**SECTION 00 91 06
ADDENDUM NUMBER 6**

**PROJECT: ORCHARD VALLEY CLUBHOUSE HVAC RENOVATIONS
2411 W ILLINOIS AVENUE
AURORA, ILLINOIS 60506**

PROJECT NO: 17-253-1110

SHEET NUMBER
A200

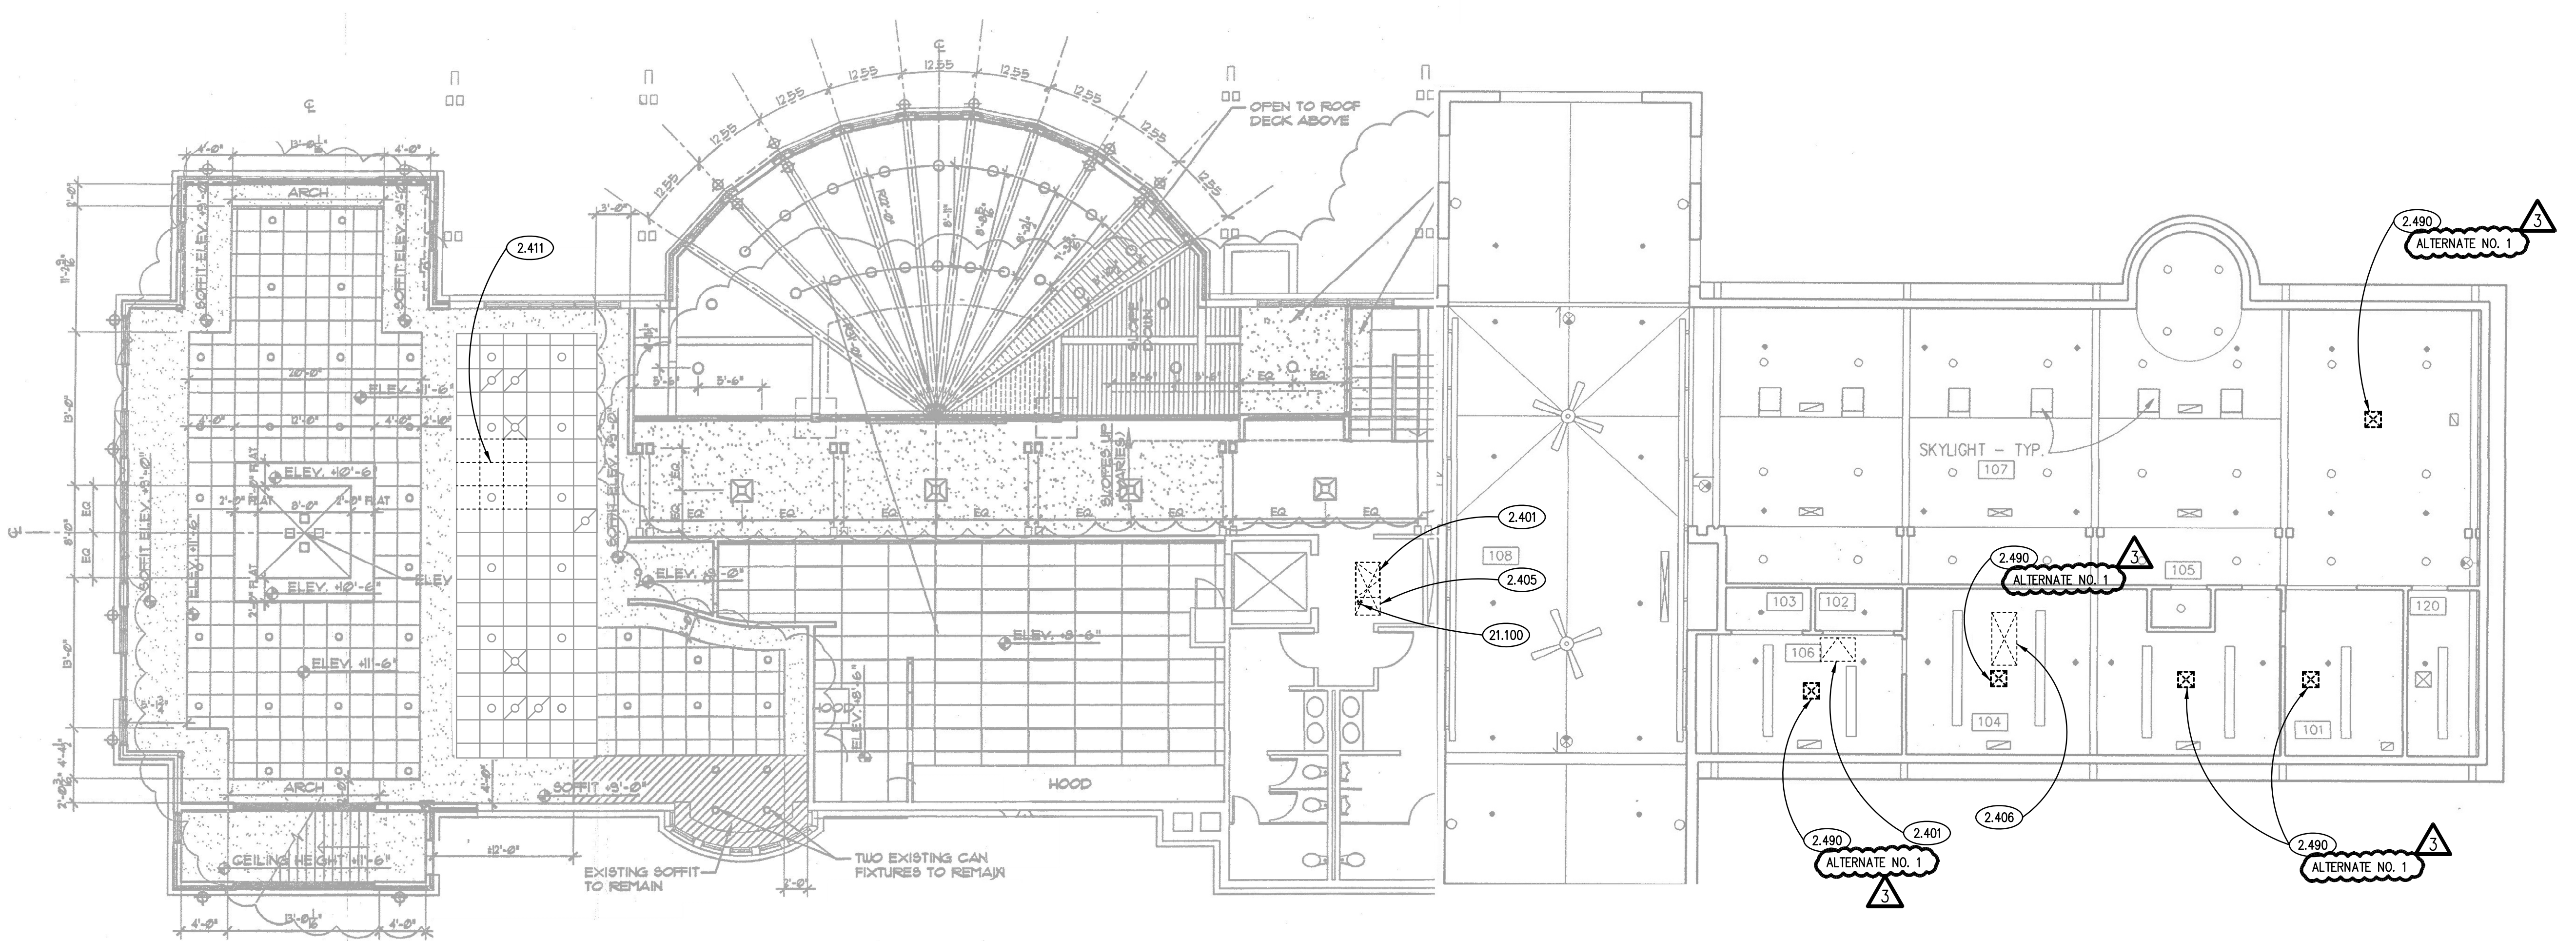
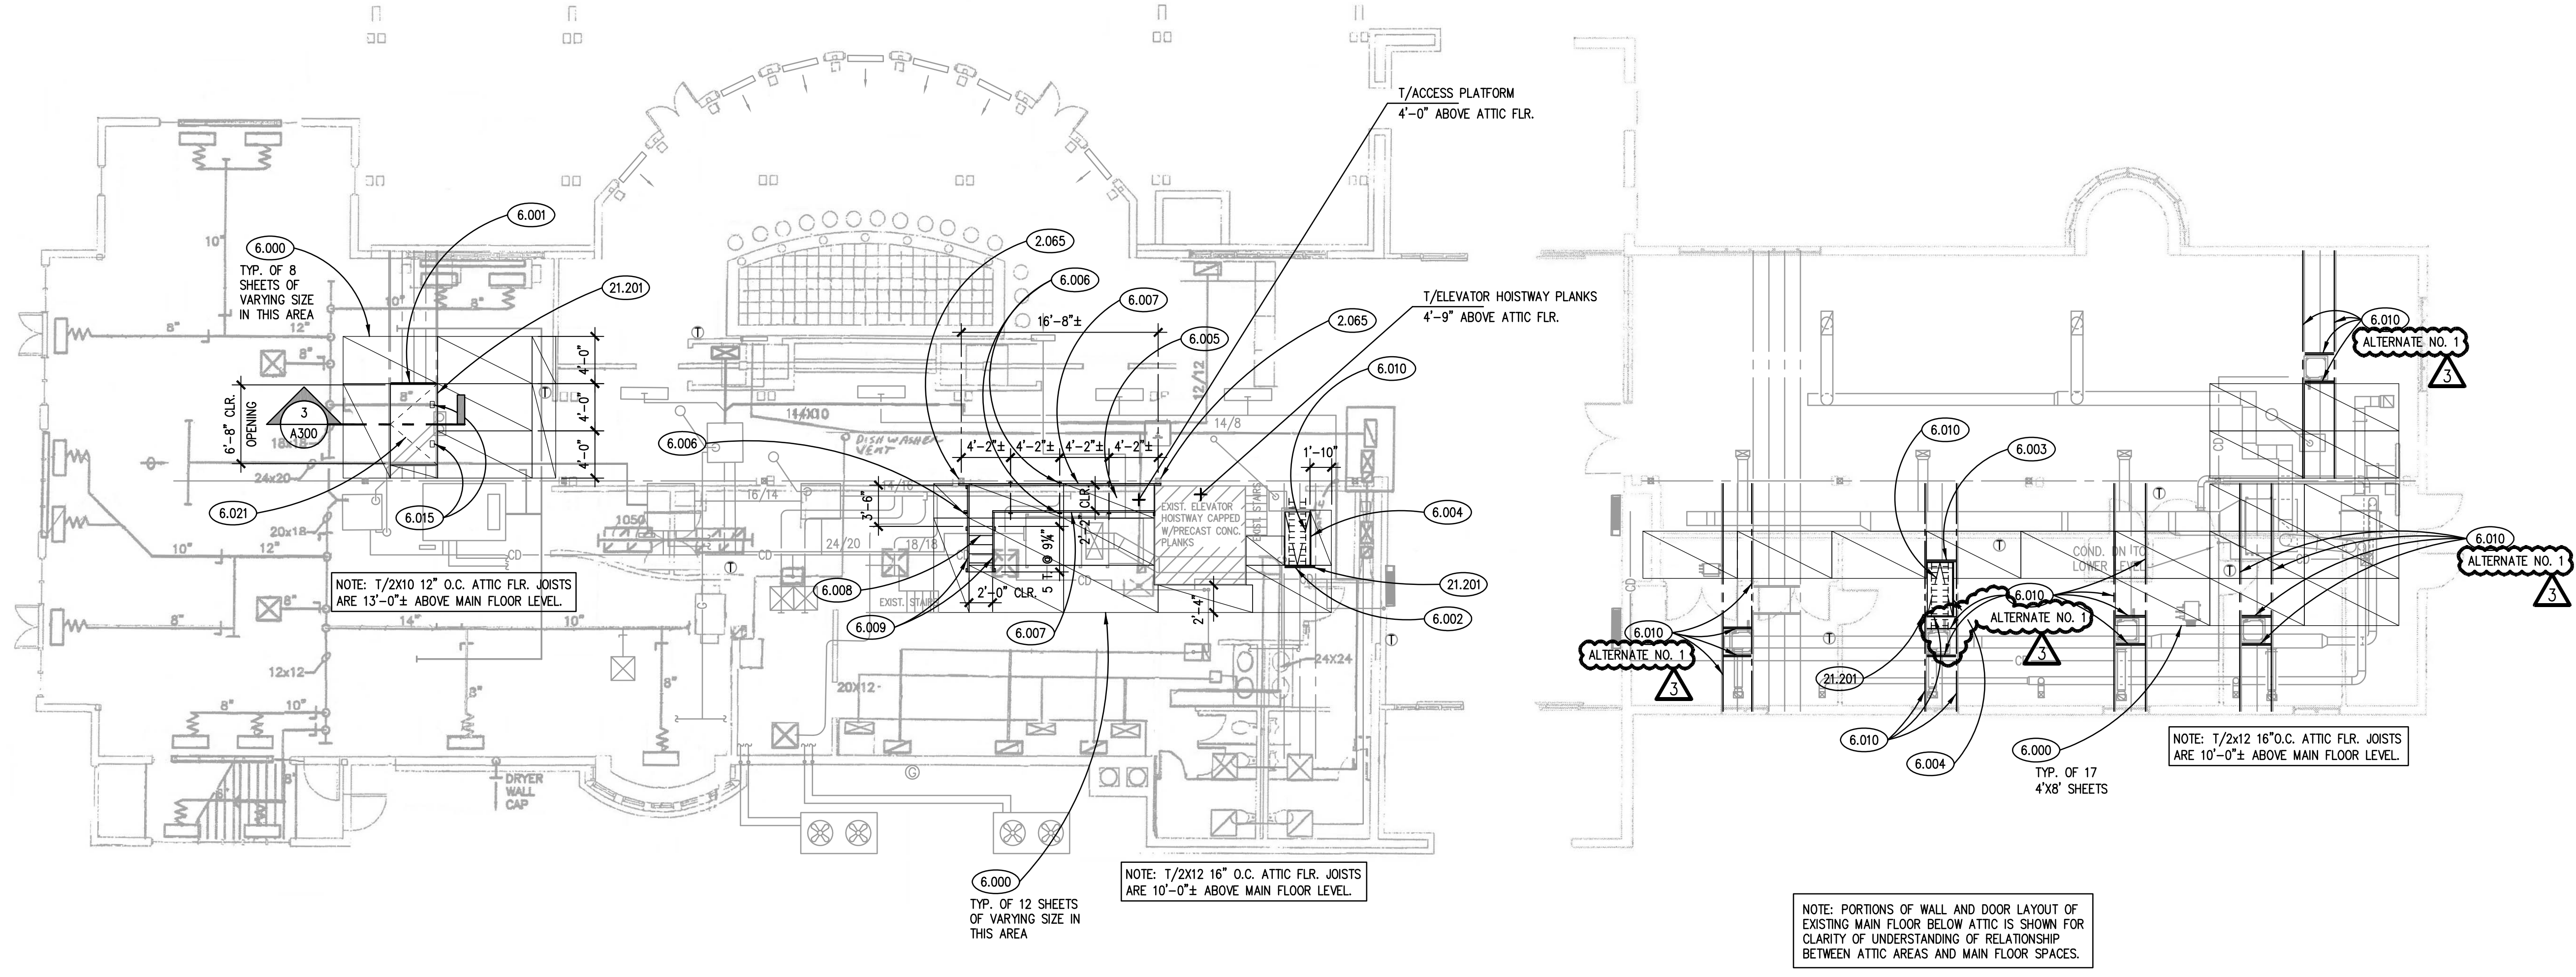
1.01 DRAWING A200 - ARCHITECTURAL DEMOLITION PLANS

- A. Delete this Drawing in its entirety and replace with revised Drawing A200 - ARCHITECTURAL DEMOLITION PLANS (attached). This revised drawing clarifies that the carpentry demo work that is part of Alternate No. 1.

A300

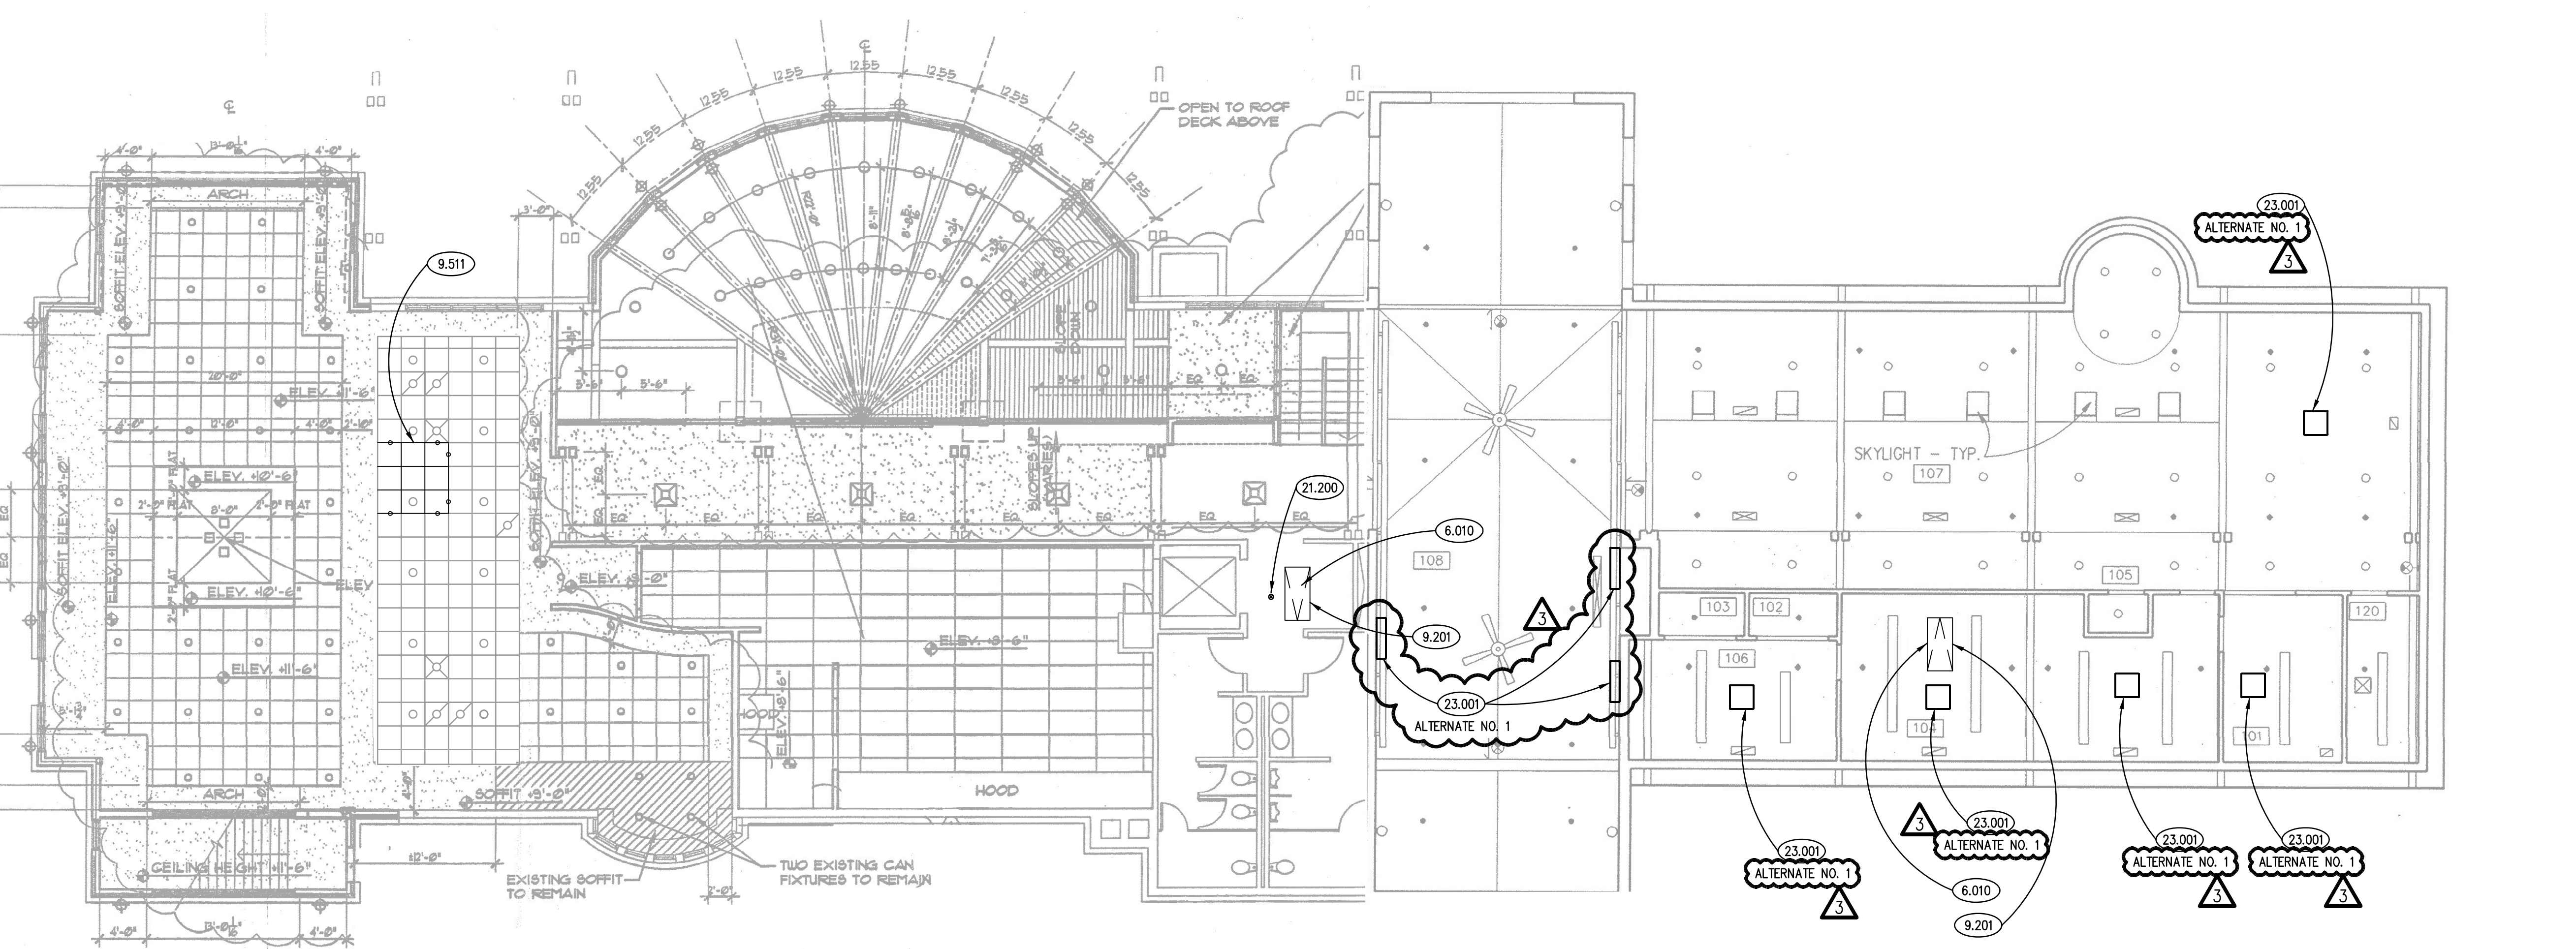
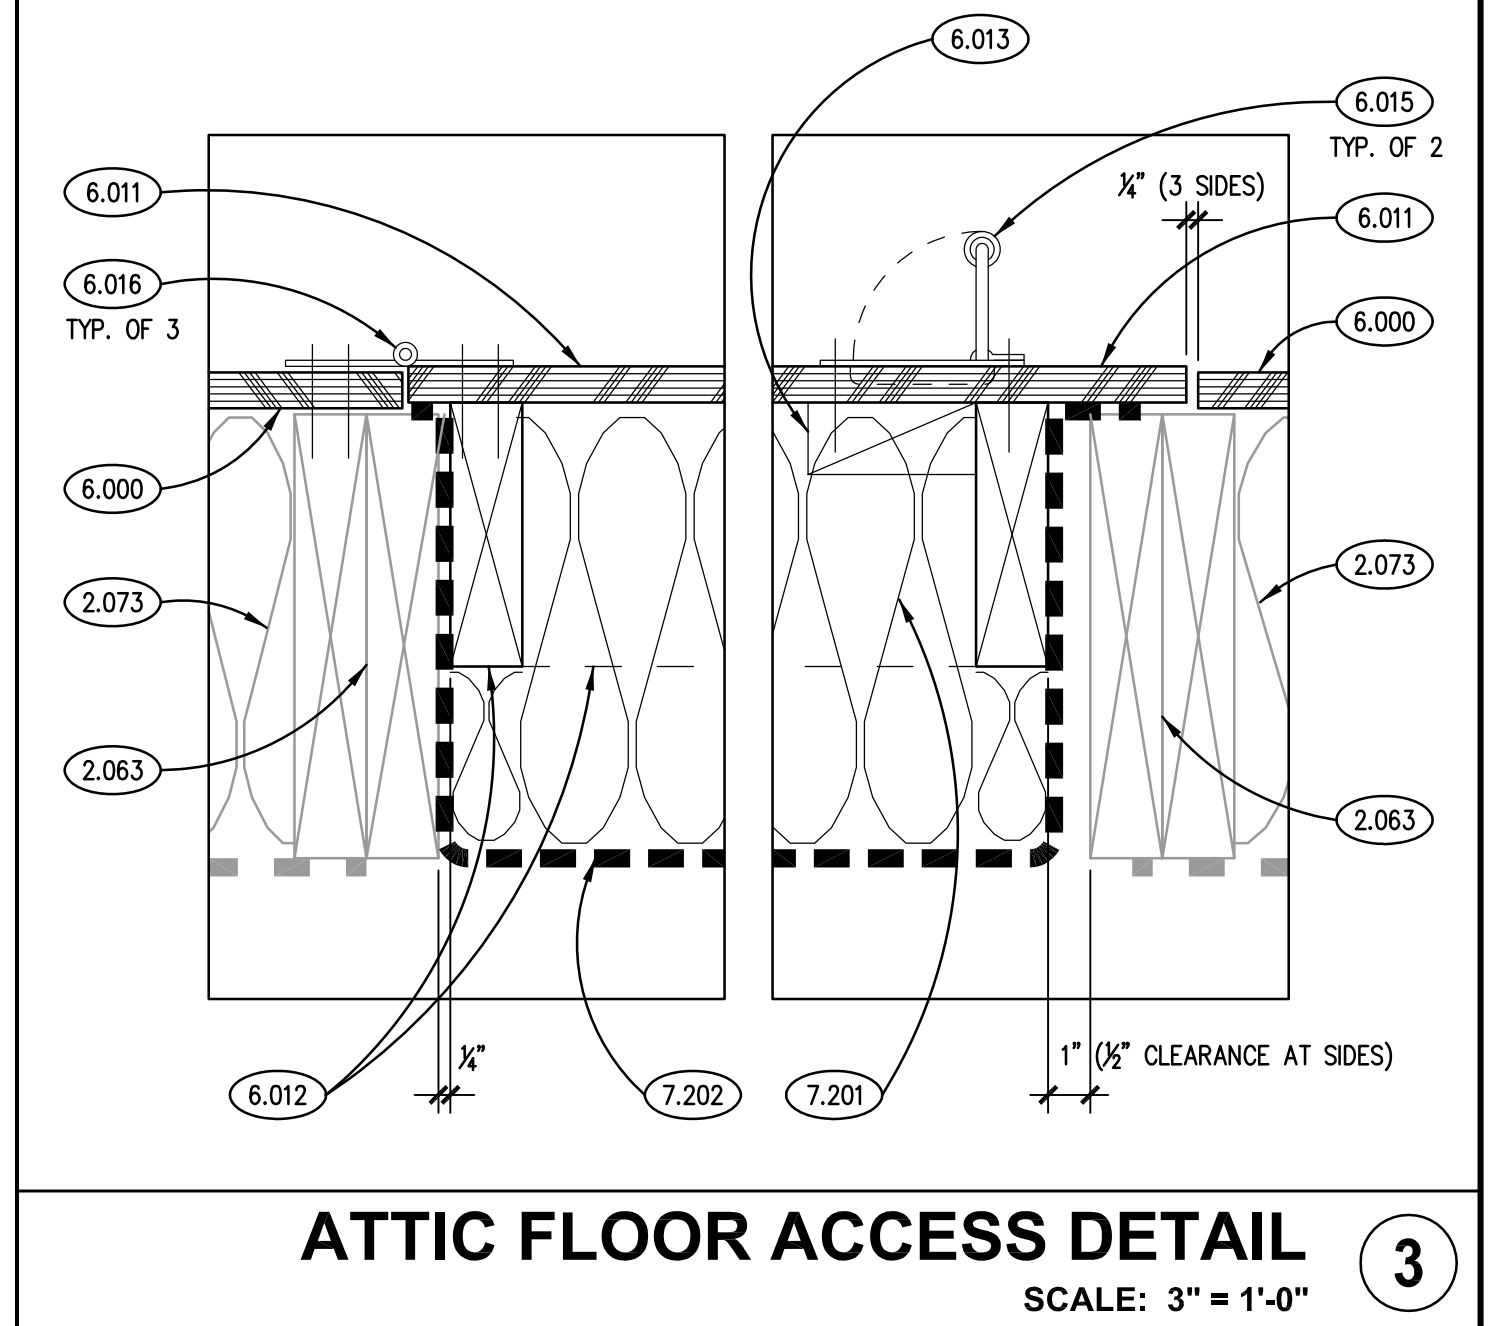
1.02 DRAWING A300 - ARCHITECTURAL PLANS

- A. Delete this Drawing in its entirety and replace with revised Drawing A300 - ARCHITECTURAL PLANS (attached). This revised drawing clarifies that the carpentry new work that is part of Alternate No. 1.
